PLANNING COMMISSION

Meeting Date: April 23rd, 2026

AGENDA ITEM: 6.A

REQUEST: Site Plan Review; Preliminary Major Condominium (Open Space Development Option)

OVERALL SITE DEVELOPMENT PLAN
CALEDONIA MEADOWS

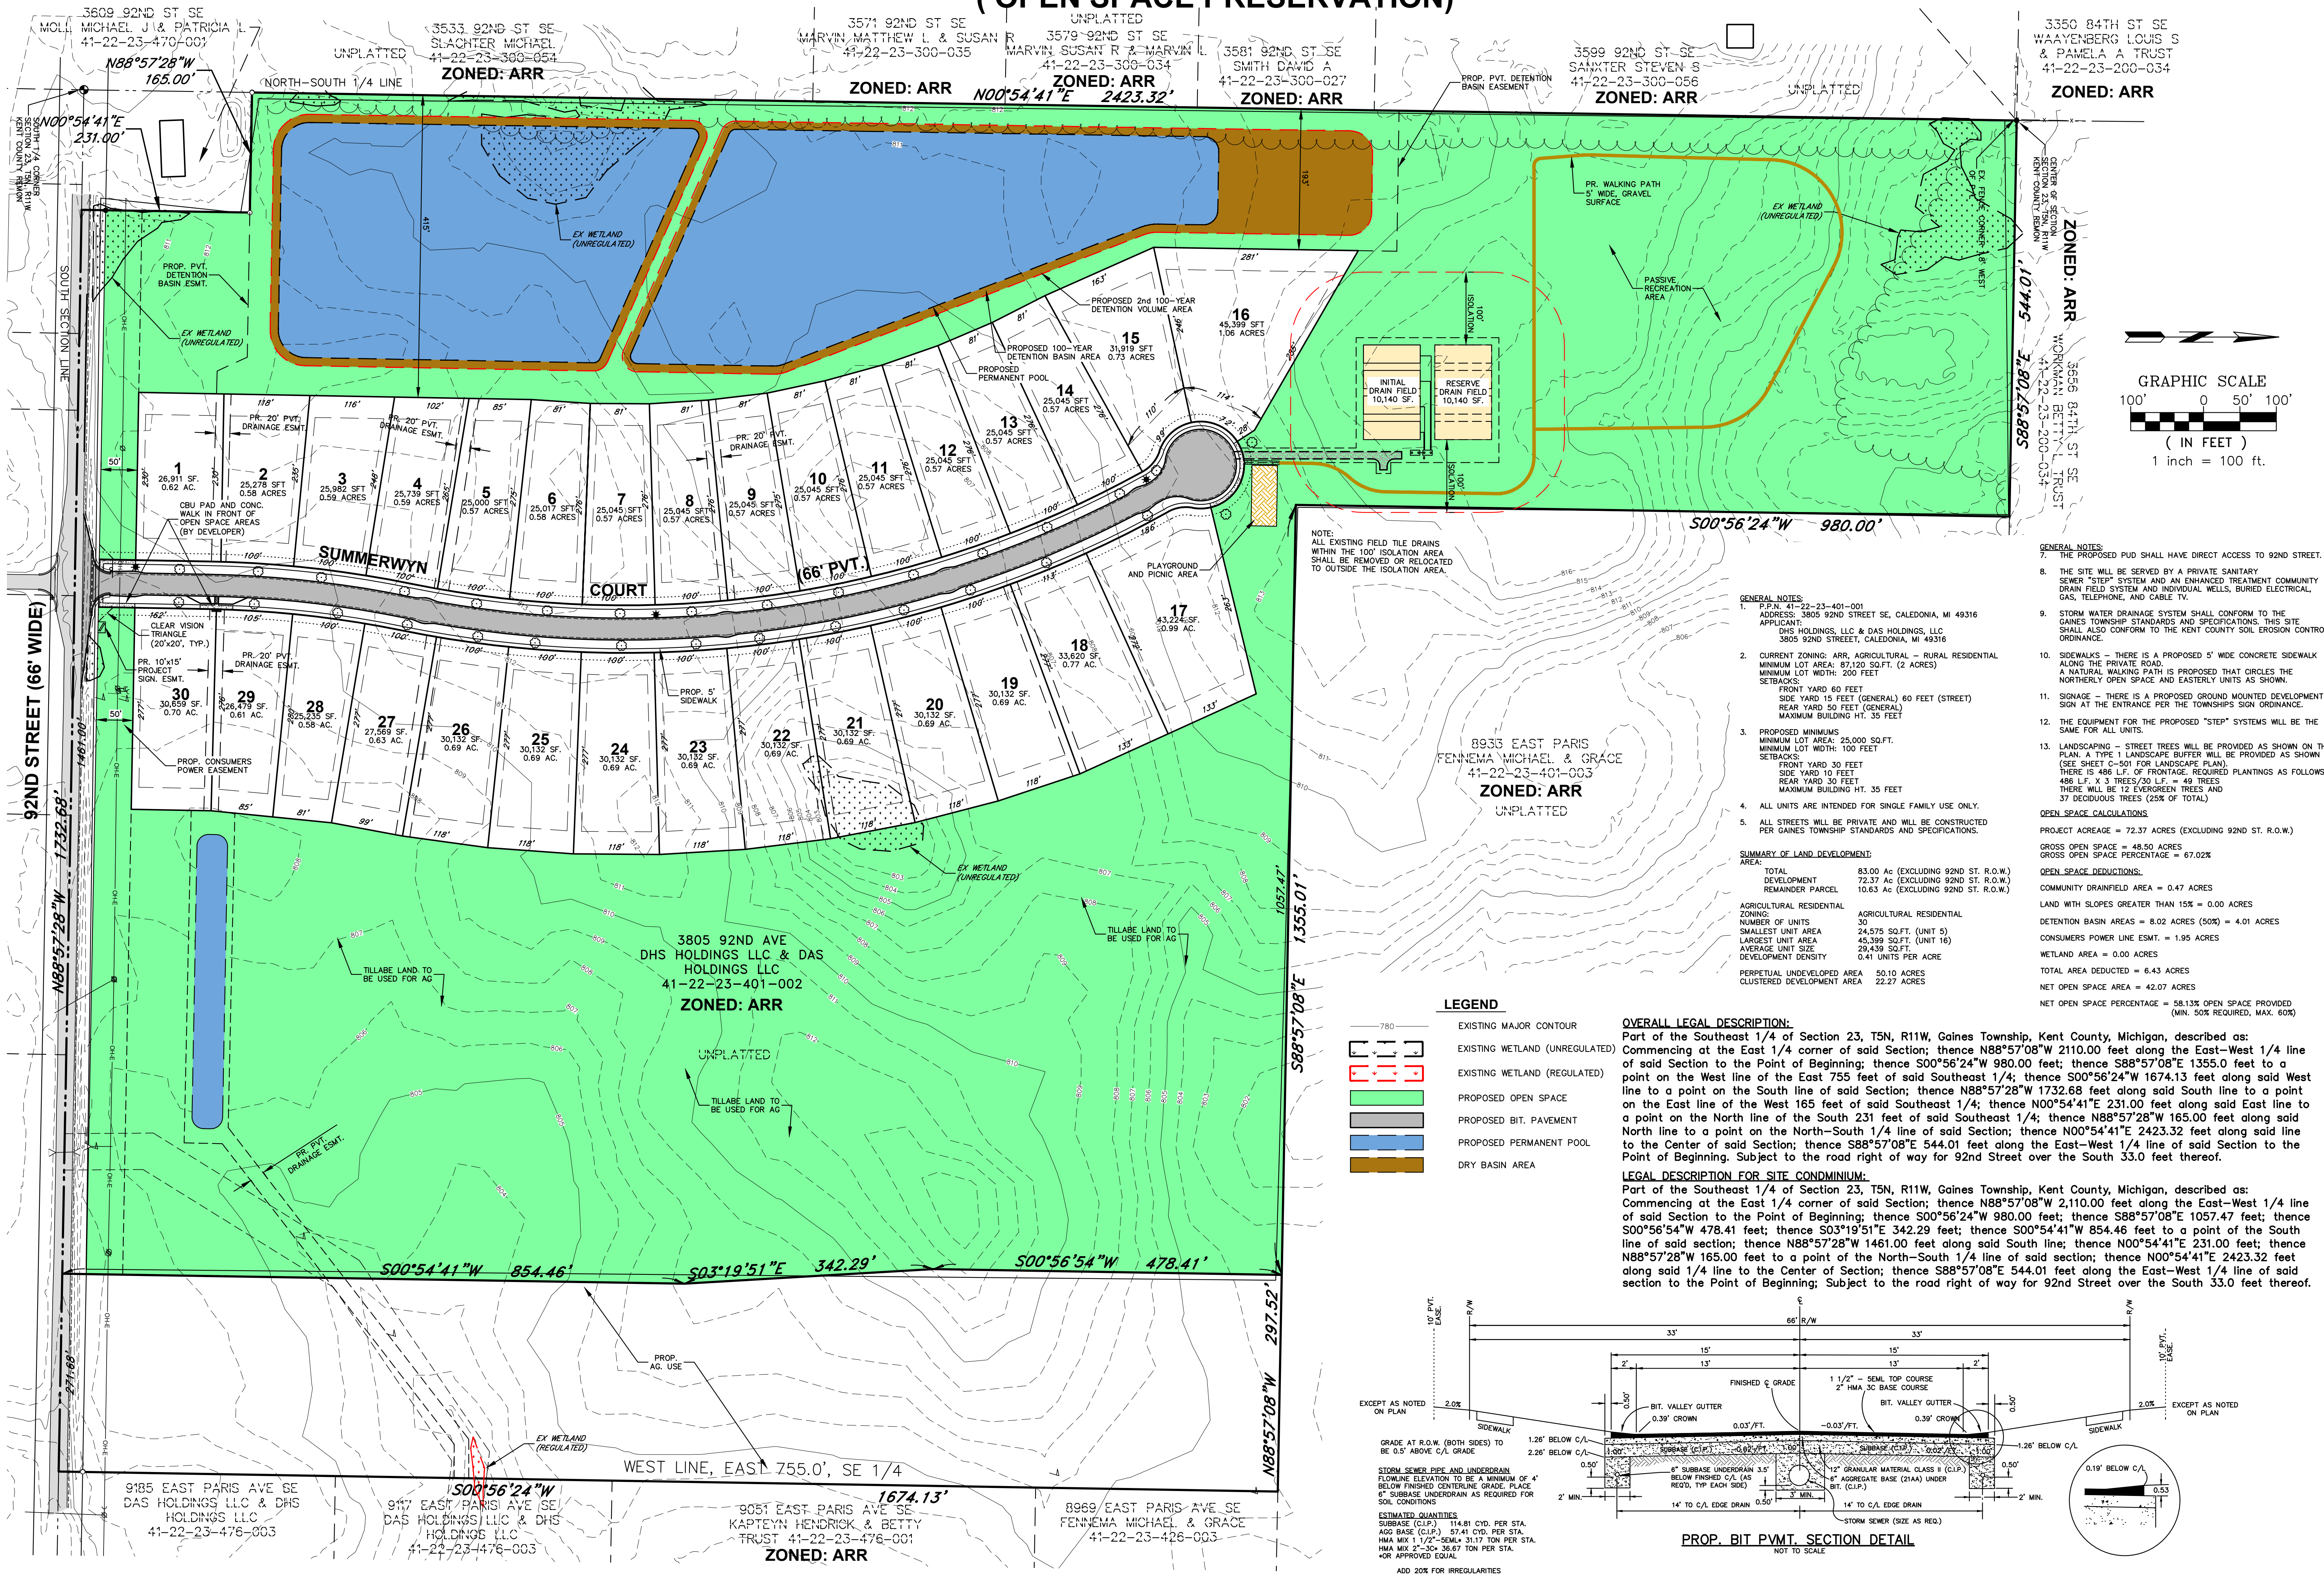
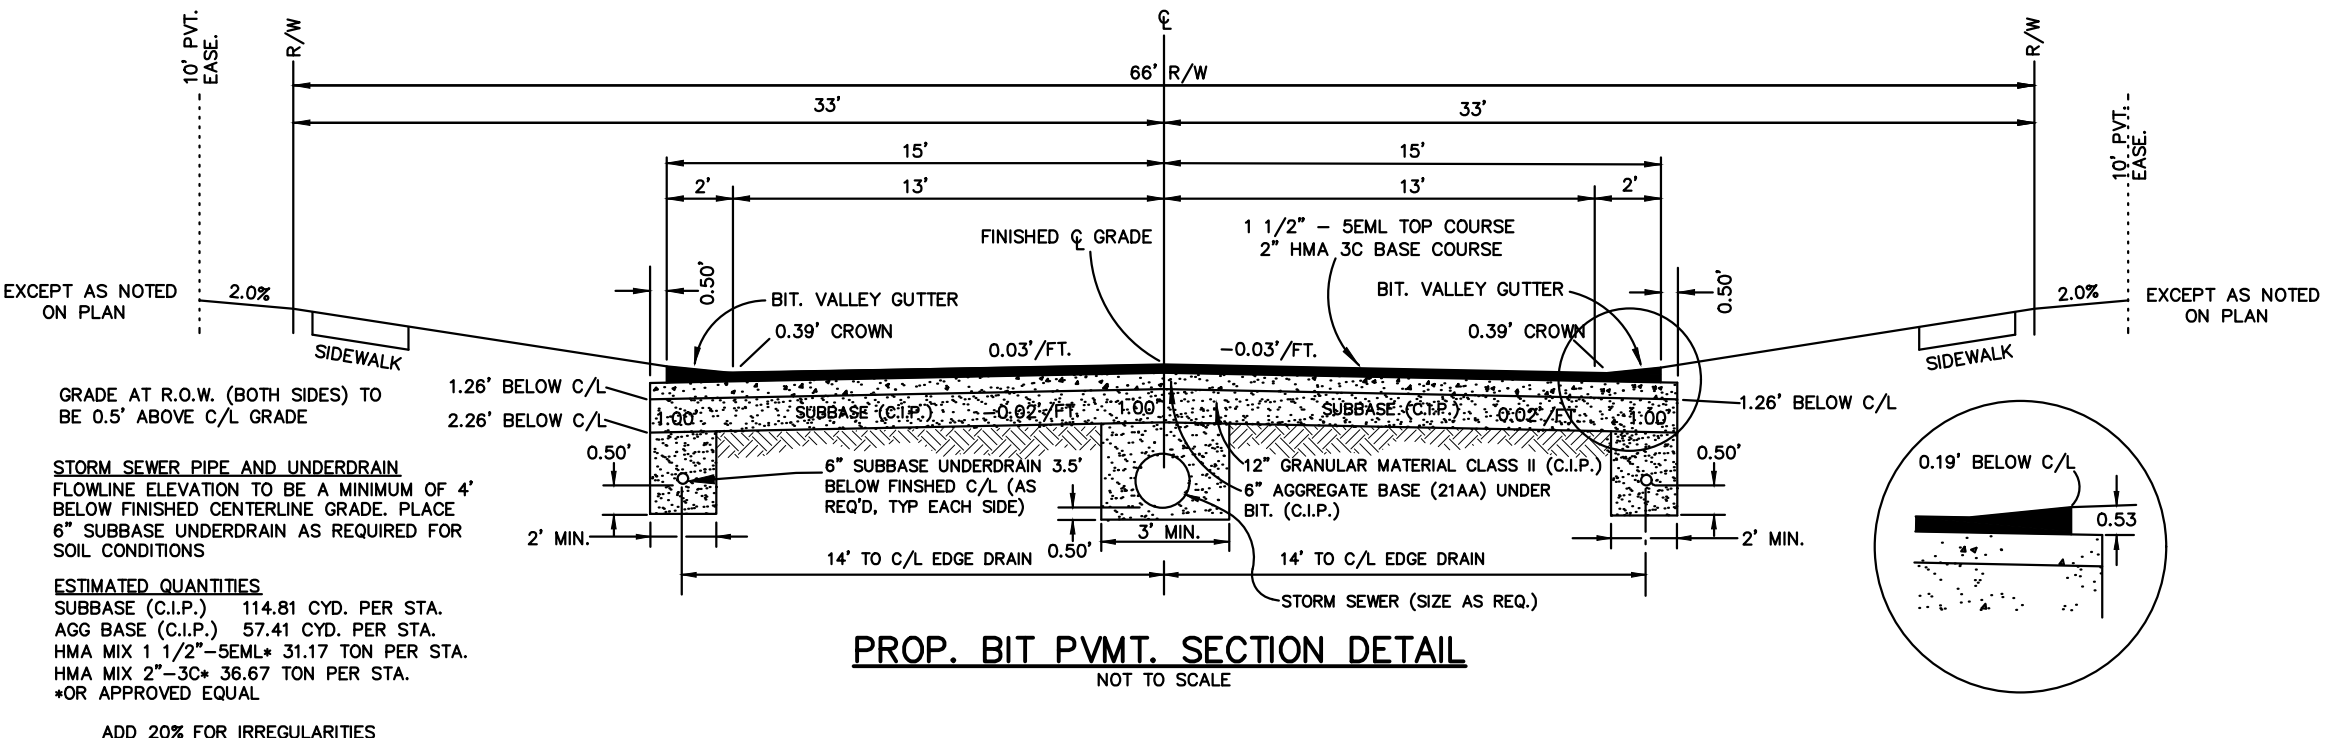
Meets standard. The provided site plans indicate that a walking path will be provided towards the north end of the property, which will circle around and encompass a passive recreational area. Although the septic drain field is adjacent to the walking path and passive recreational area, the area of said infrastructure was omitted from open

Meets standard, condition recommended. The open space to the north of the home sites will be accessible via a 5-foot-wide sidewalk which runs along the interior perimeter of the cul-de-sac on both sides of the street. The applicant has specified that the 5-foot-wide walking path which circles the passive recreational area is planned to have a gravel surface; staff recommends the material be changed to a hard-surface path to provide adequate accessibility for all forms of pedestrian mobility.

Meets standard. The provided site plan indicates a 50-foot-wide buffer between the side yards of lots 1 and 30 and the 92nd Street right-of-way. The landscaping plan dated 03/26/2026 indicates that 49 trees will be planted in the buffer zone which is anticipated to adequately buffer the view once trees mature. The landscaping plan specifies that mature trees within the Consumers Energy easement will not exceed 20 feet in height.
